Comments on the Gazebo project proposed by 8636 House owner Cui

I reviewed the updated plan for the Gazebo project under SUB3 and 5, It looks good and I see they made corrections on the location of the new Gazebo to meet setback requirements.

8636 N MERCER WAY RESIDENCE
8636 N MERCER WAY, MERCER ISLAND, WA

Mercer Island Pergola

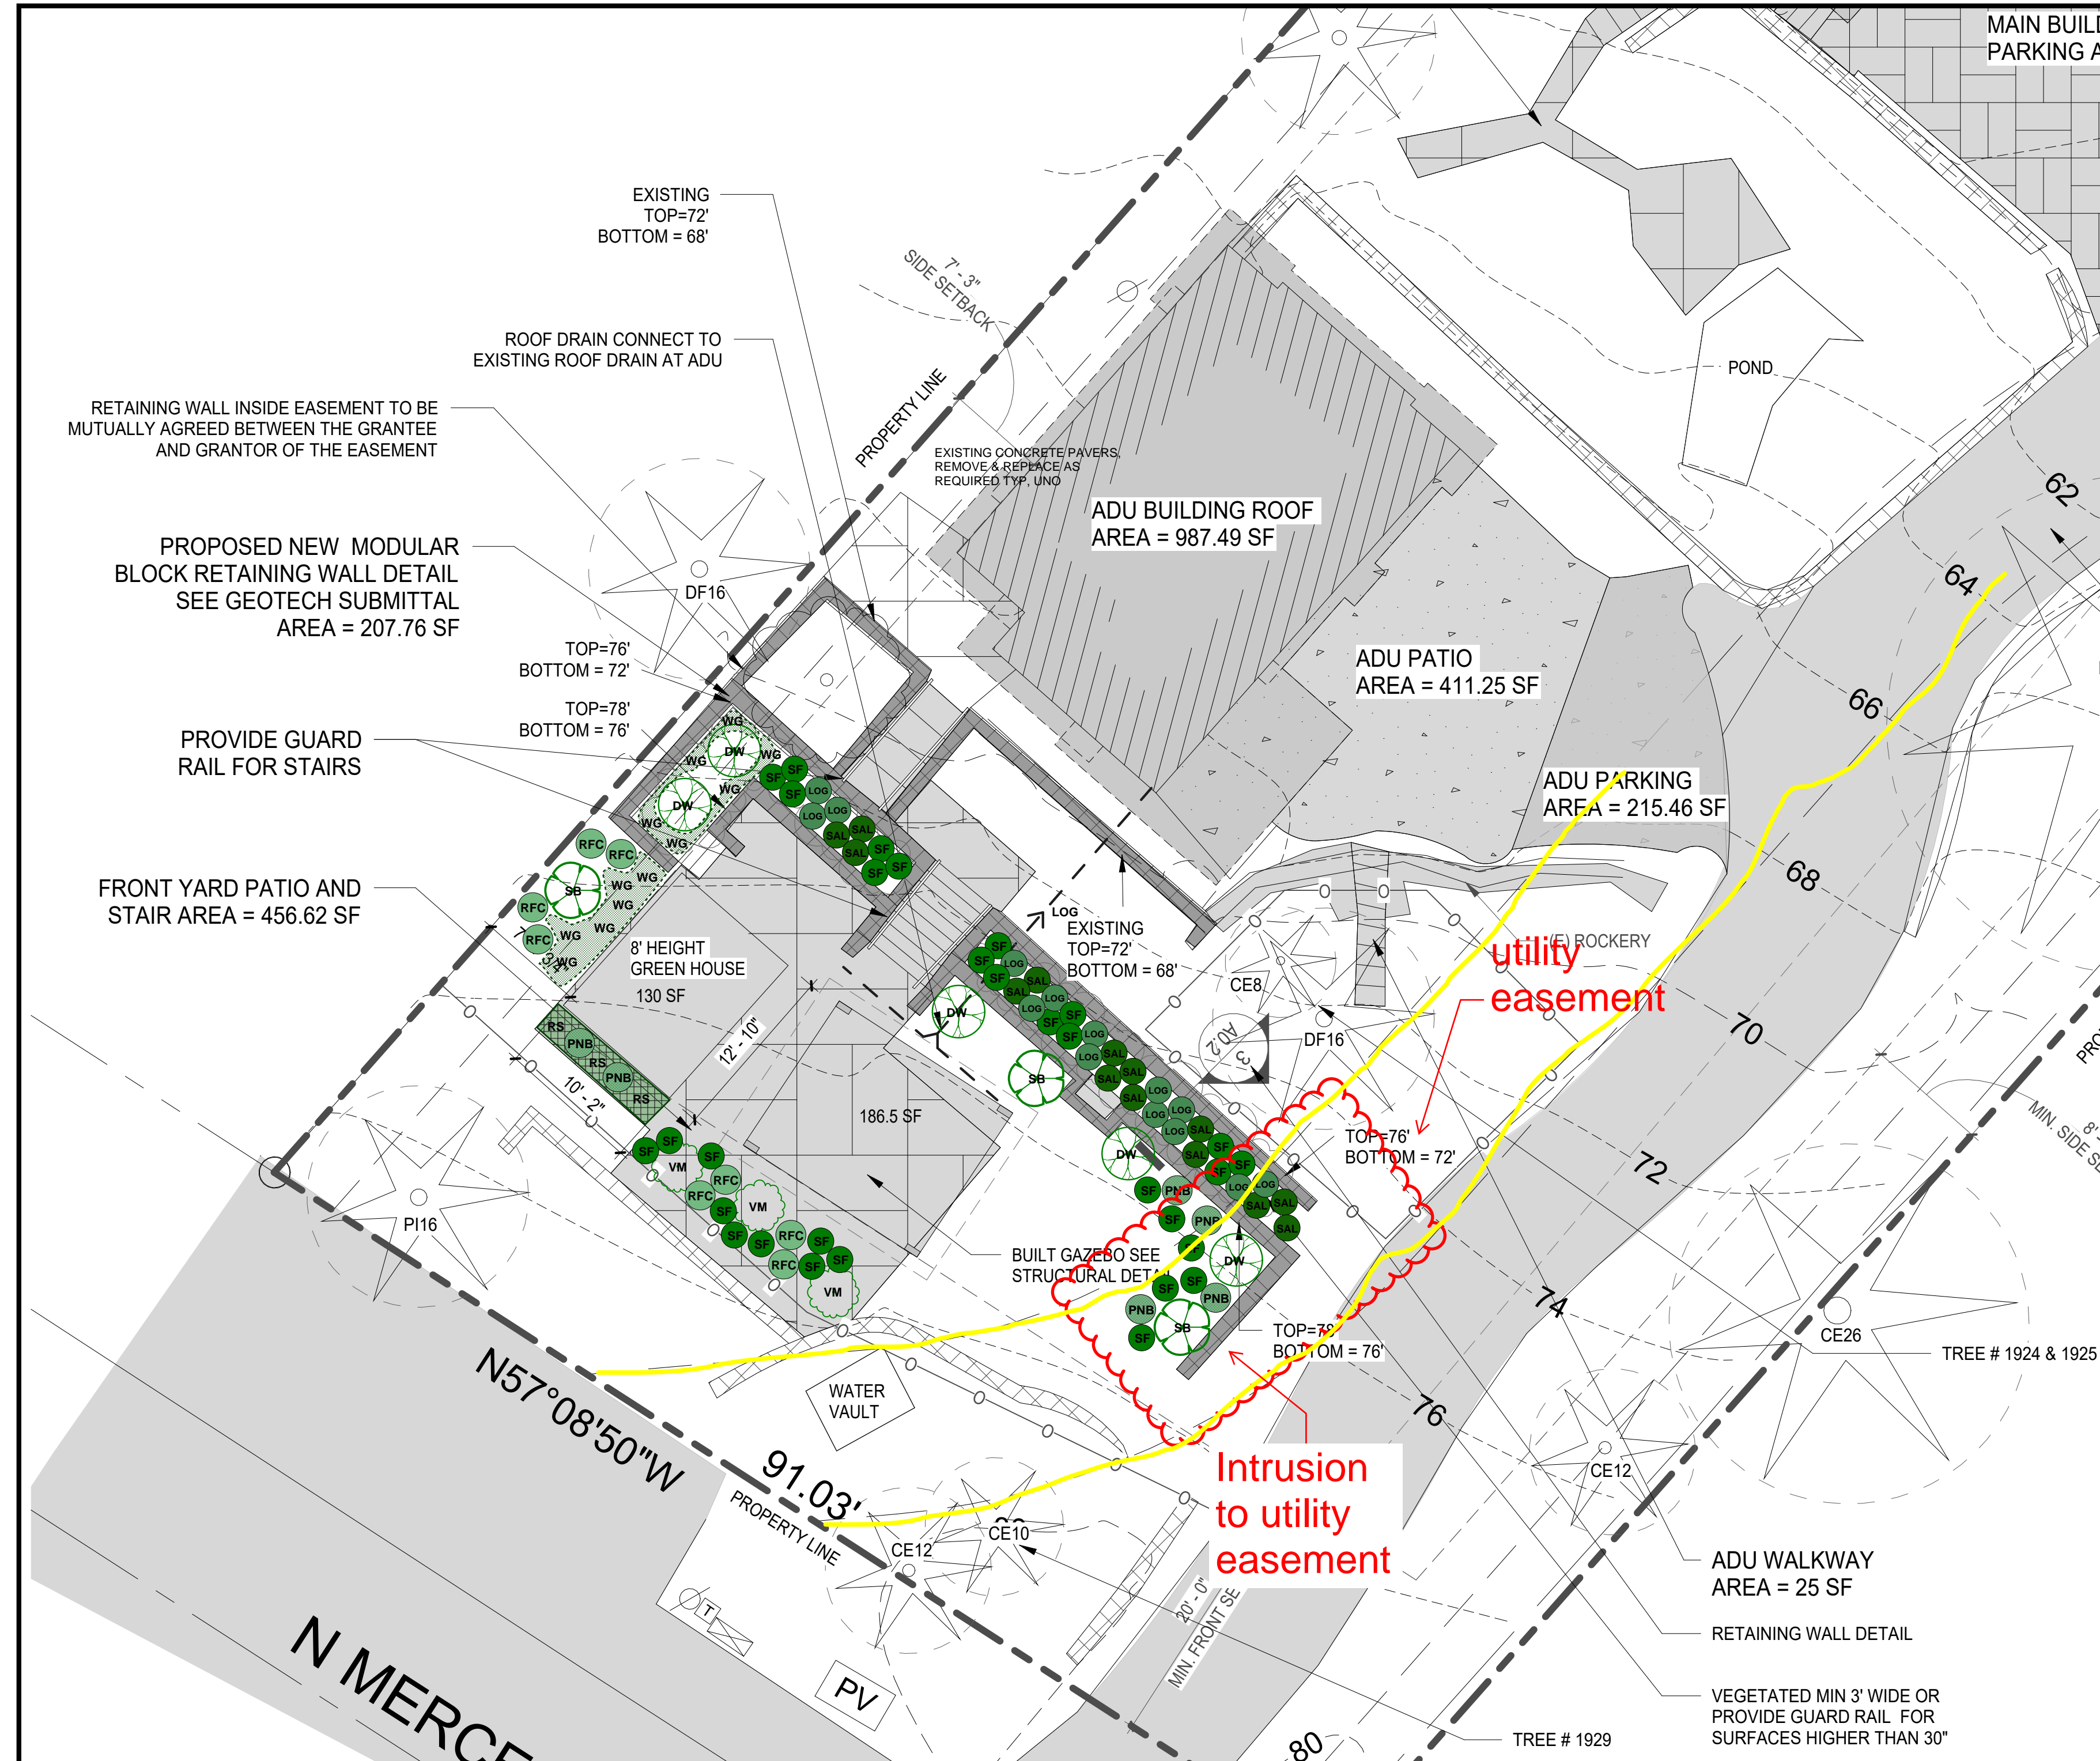
1. The retaining wall is still located within the utility easement, and I also noticed that several shrubs are positioned inside this area. As far as I understand, no structure—including a retaining wall—should be placed within a utility easement, as it would obstruct access for maintenance or emergency purposes.
2. The plan does not show the existing gazebo location (that is non-compliance), nor include a demolition plan for removing the existing structure (non-compliance). Without this information, it may give out a wrong message to the contractor. The plan should include this information so it is very clear for the purpose of this permit - the job requires a re-building of the structure.
